RE: S/D 99-13 -- One-Step Final Plat of BOOHER 2ND ADDITION

RE: S/D 99-13 -- One-Step Final Plat of BOOHER 2ND ADDITION

**STAFF REPORT**  
(One-Step Final Plat Approved 3/4/99)

**CASE NUMBER:** S/D 99-13 - BOOHER 2ND ADDITION

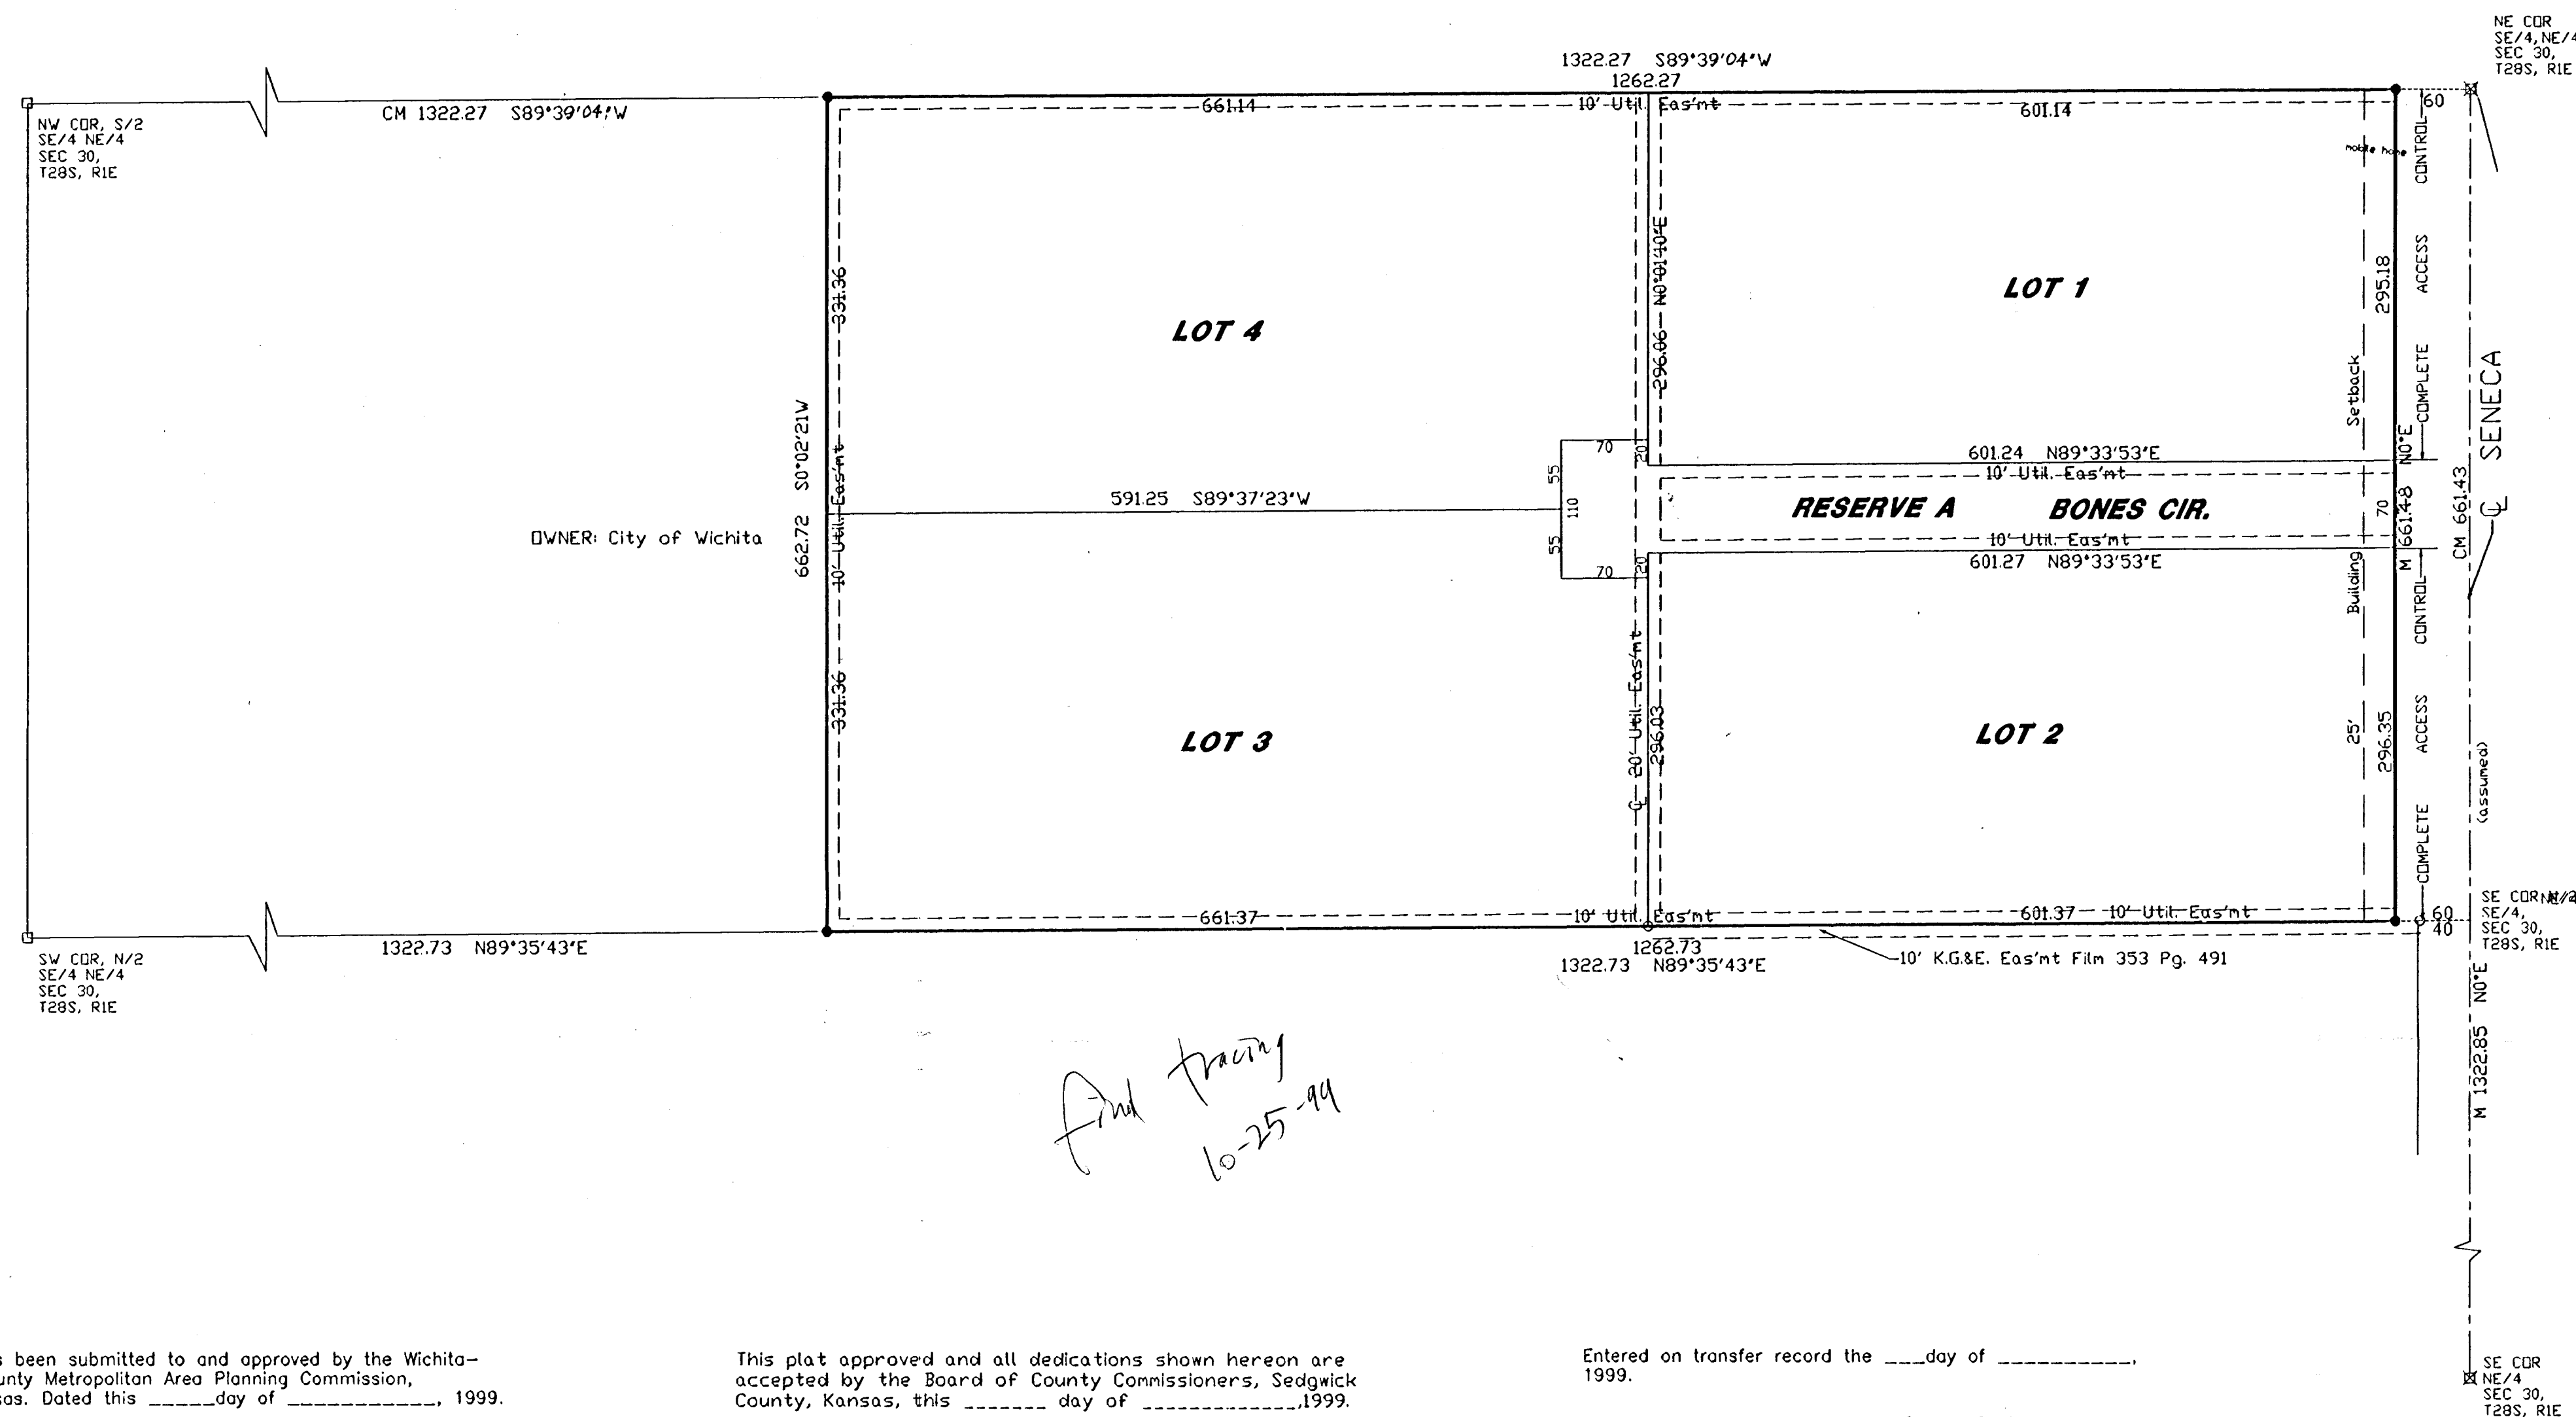
A. Since neither municipal water nor sanitary sewer is available to serve this property, the applicant shall contact the Environmental Health Division of the Health Department to find out what tests may be necessary and what standards are to be met for approval of on-site sewerage facilities and water wells. A memorandum shall be obtained specifying approval.

✓ A revised lot layout is needed indicating at least 4.5 acres per lot unless the site is approved for septic systems.

→ B. Since this site is within one-quarter mile of the City limits, City Engineering needs to comment if guarantees for future extension of sanitary sewer and City water need to be provided at this time. A guarantee for future extension of City water is required.

→ D. County Engineering needs to comment on the status of the applicant's drainage plan. The drainage plan needs to be reviewed.

E. The applicant proposes a private street to access the four lots. Subdivision regulations require private streets to be platted as reserves. These reserves need to be platted as distinct entities and not denoted as part of any adjoining lot.

→ F. A covenant shall be submitted regarding the reserve platted for private drive purposes, which sets forth ownership and maintenance of the private drive, and future reversionary rights of

the reserve to the lots benefiting from the reserve. The platlor's text shall reference the platting of the reserve for private drive purposes along with ownership and maintenance responsibilities.

- G. The final plat tracing shall denote complete access control along Seneca to the north and south of the private street. Access controls shall be referenced in the platlor's text.

- H. The private street shall be designated a name and approved by the County Fire Department. *Bones Circle is recommended*
- I. The County Commissioners signature block needs to be revised to reference "Thomas G. Winters" and "Bill Hancock".

- J. The MAPC signature block needs to be revised to reference "William M. Johnson".
- K. According to the platting binder, a blanket pipeline easement appears to have been granted over the plat. The applicant shall either obtain a release of this easement or provide proof that the easement has been confined. If confined, any portion of the easement if on this plat shall be shown and the pipeline's name and recording information shown.

- L. The applicant shall guarantee the installation of the private street to a public street standard. As a private improvements, such guarantee shall not be provided through the use of a petition.

- M. County Fire needs to comment on the acceptability of the hammerhead turnaround.
- N. The applicant shall install or guarantee the installation of all utilities and facilities which are applicable and described in Article 8 of the MAPC Subdivision Regulations. (Water service and fire hydrants required by Article 8 for fire protection shall be as per the direction and approval of the Chief of the Fire Department.)

- T. Recording of the plat within thirty (30) days after approval by the City Council and/or County Commission.
- U. The representatives from the utility companies should be prepared to comment on the need for any additional utility easements to be platted on this property. Southwestern Bell and KGE have requested additional easements.
